UNION CARBIDE CORPORATION

CORPORATE RESEARCH LABORATORY

Subj: PROPOSED AMENDMENT TO SPECIAL NUCLEAR MATERIAL
(SNM) LICENSE No. 639.

FIGURE 1

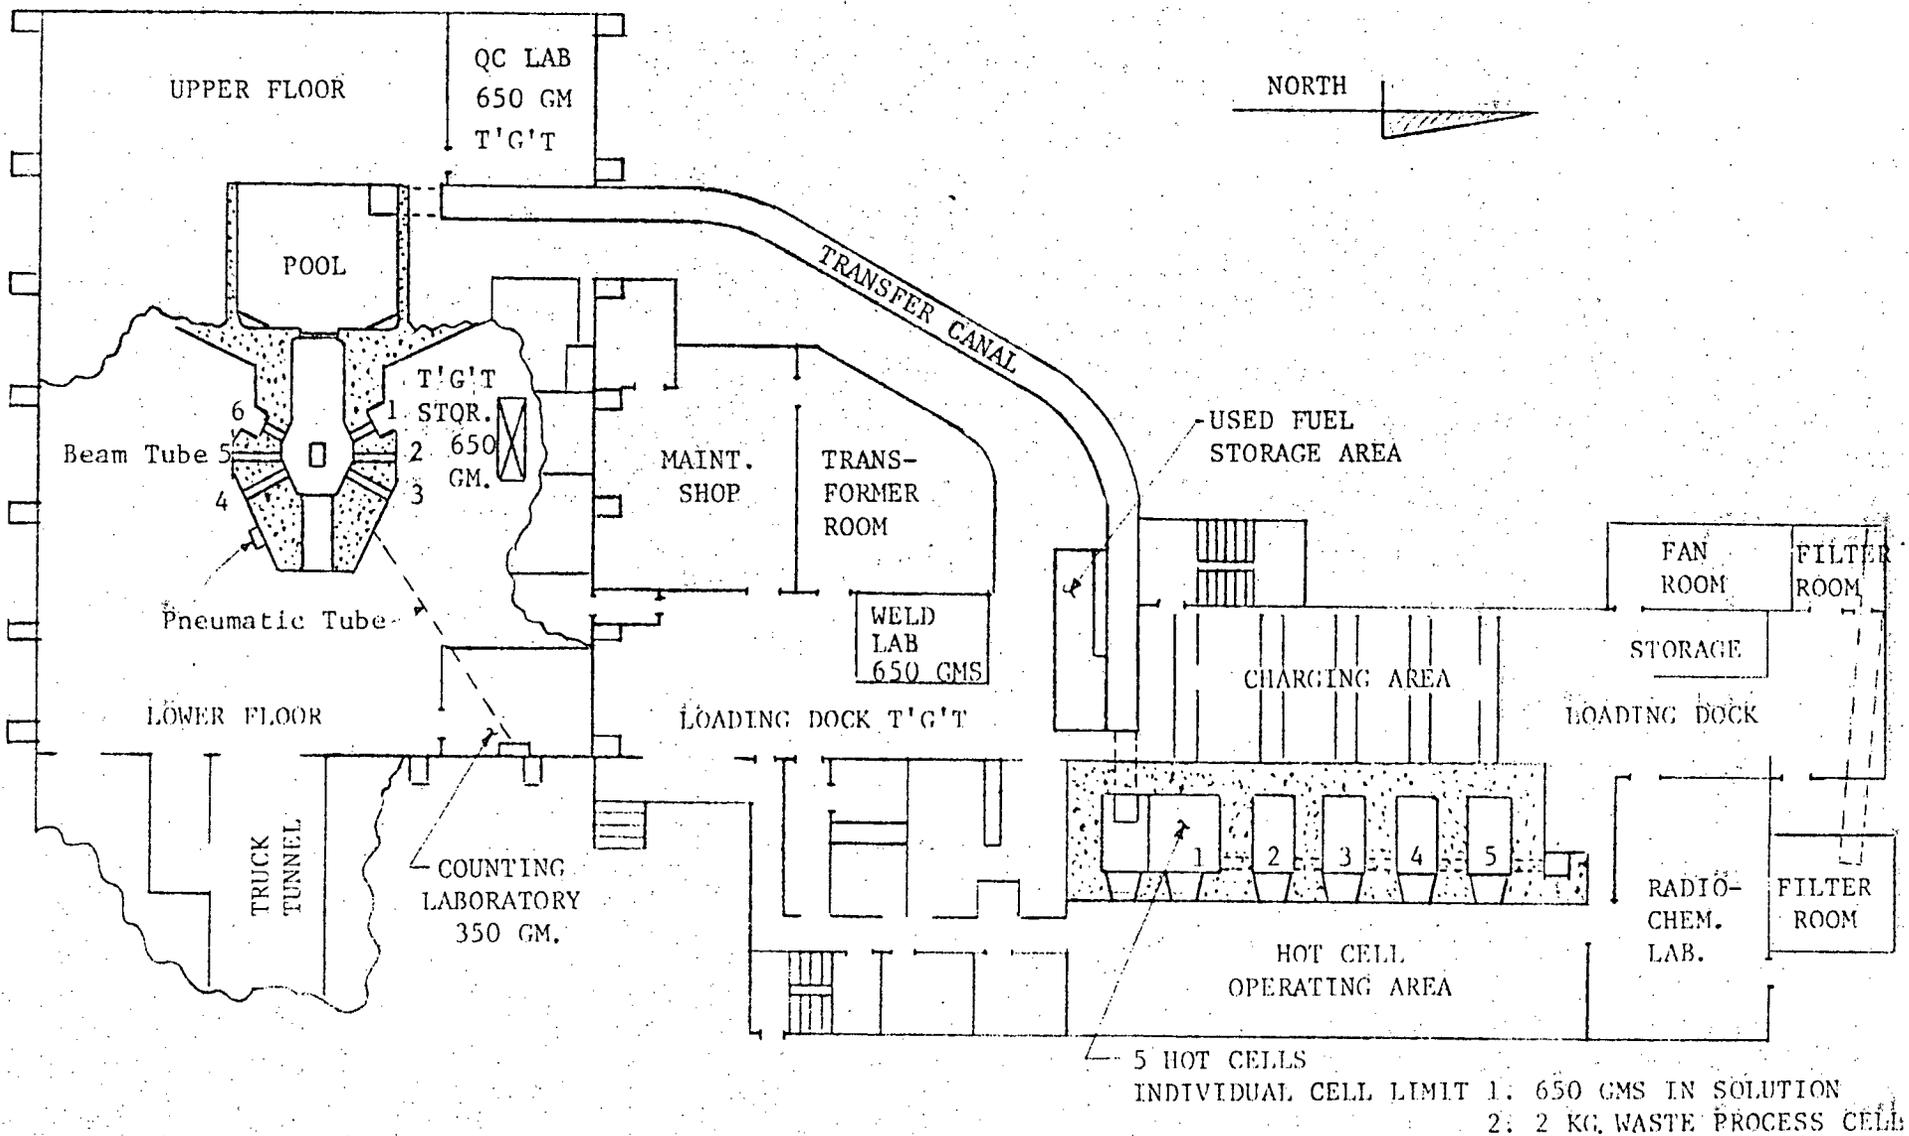
Revised floor plans are included to reflect the current storage locations and processing laboratories. A check in the amount of \$150.00 is enclosed to cover the administrative fee requirements of 10 CFR 170.31.

FIGURE 1A

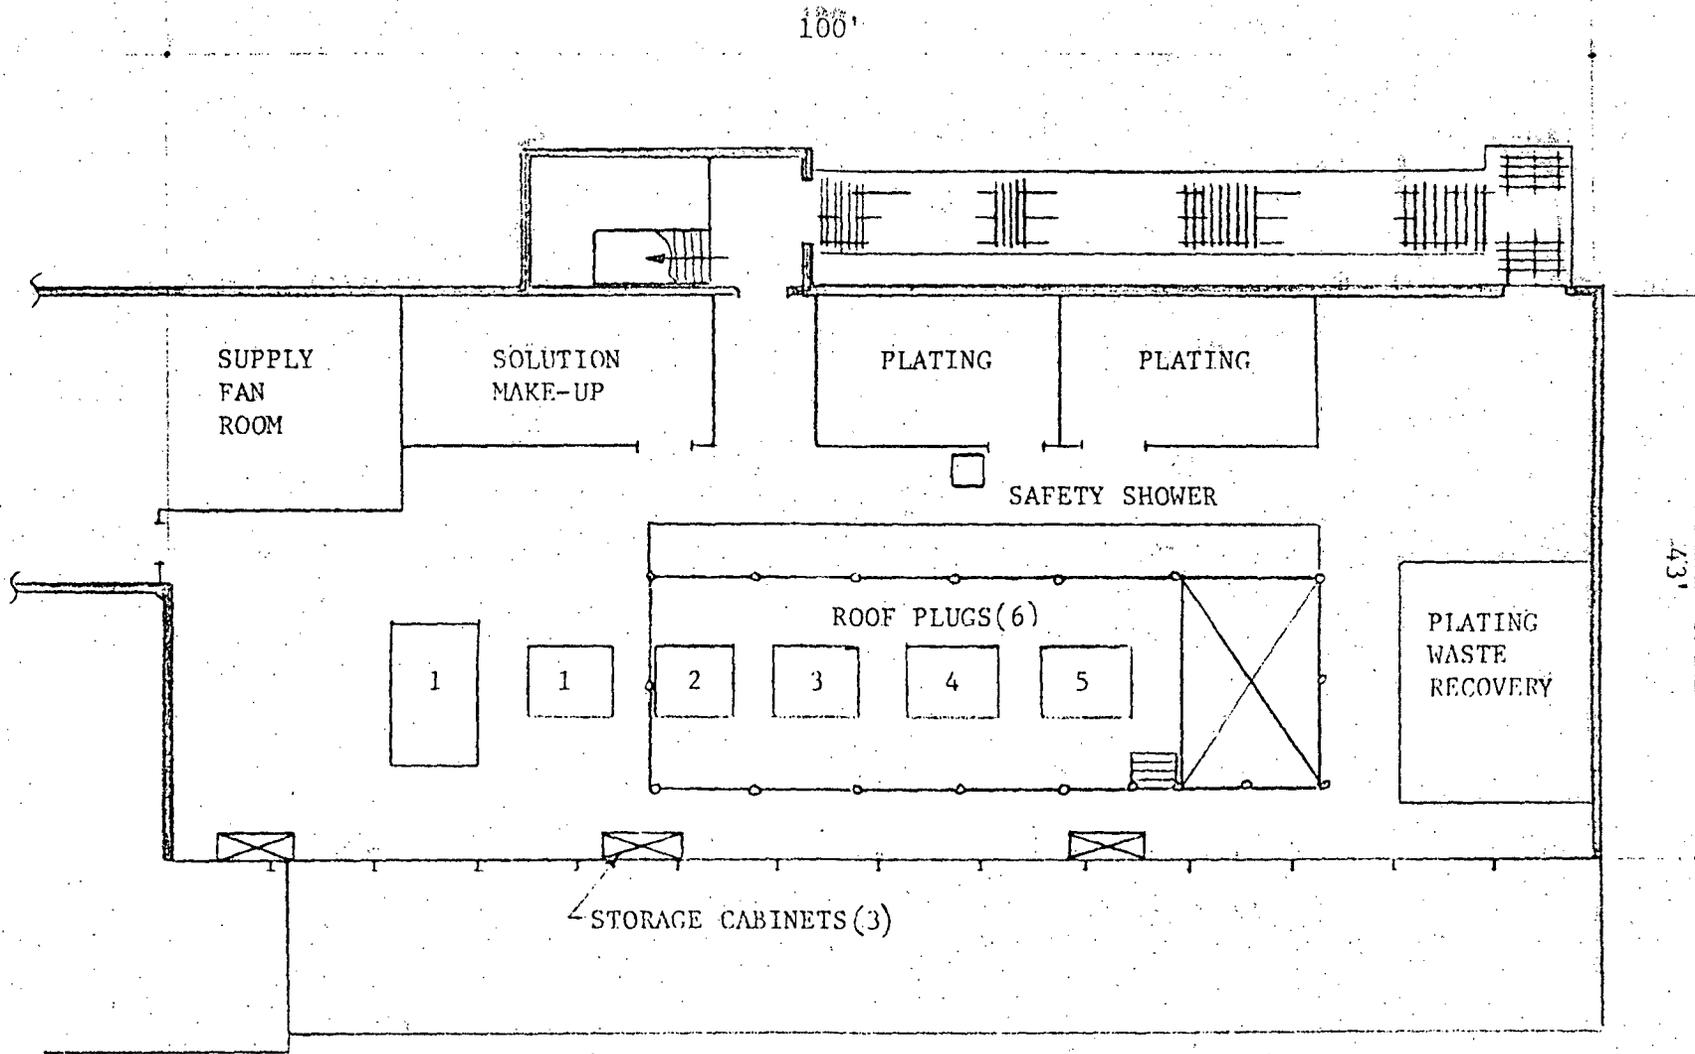
"A.2. All unirradiated SNM when not in use, shall be kept in locked steel cabinets which are located within a restricted area of the hot laboratory. The amount of U-235 in a single cabinet shall be limited to 350 grams in solution or 650 grams as  $UO_2$  or  $U_3O_8$ . The spacing between SNM storage cabinets shall be a minimum of three feet and each cabinet shall be fastened to prevent inadvertent movement. SNM in liquid form shall be doubly contained."

Uranium is stored in storage cabinets in the upper level of the hot laboratory (Fig. 1A). Material in liquid form is doubly contained. Storage cabinets are of fireproof construction, are separated by a minimum distance of three feet and are fastened to prevent inadvertent movement. All cabinets are locked and keys are in the custody of the SNM custodian for the area. Criticality control is implemented by limiting the quantity of SNM in solution to 350 grams per storage cabinet. This limit allows a safe margin below the single parameter limit of 760 grams U-235 in uniform aqueous solutions specified in the ANSI N16.1-1969 standard even

if "double batching" were to occur. The storage space within each cabinet is large enough for only one 350 gram batch of material in solution and therefore it is unlikely that double batching could occur but in the event that it did the 760 gram single parameter mass limit would not be exceeded. In the event it is necessary to store SNM as  $UO_2$  or  $U_3O_8$ , the quantity limit for this form of material shall be 650 grams of SNM. This quantity is not likely to be exceeded because of the 650 gram order limit previously discussed. The quantity is well below the 29.6 Kg or 43.5 Kg subcritical mass limits stated for dry  $UO_2$  or  $U_3O_8$  respectively as presented in Table 3.1 of Nuclear Safety Guide TID 7016 Rev. 2, p. 71. Due to the location of the storage facilities, it is not credible that this material would be contacted by water or other moderating material."

- "A.3. Unirradiated SNM in solution shall not exceed 350 grams in a single laboratory."
- "A.4. SNM, as an oxide, encapsulated for irradiation shall not exceed 650 grams in a single laboratory. When SNM is in process in the plating lab (Fig. 1A), it can be either as a solid (oxide) or in solution (electrolyte 15 gms/liter, H:U  $\approx$  1500) and the quantity of either form shall be governed by the formula:
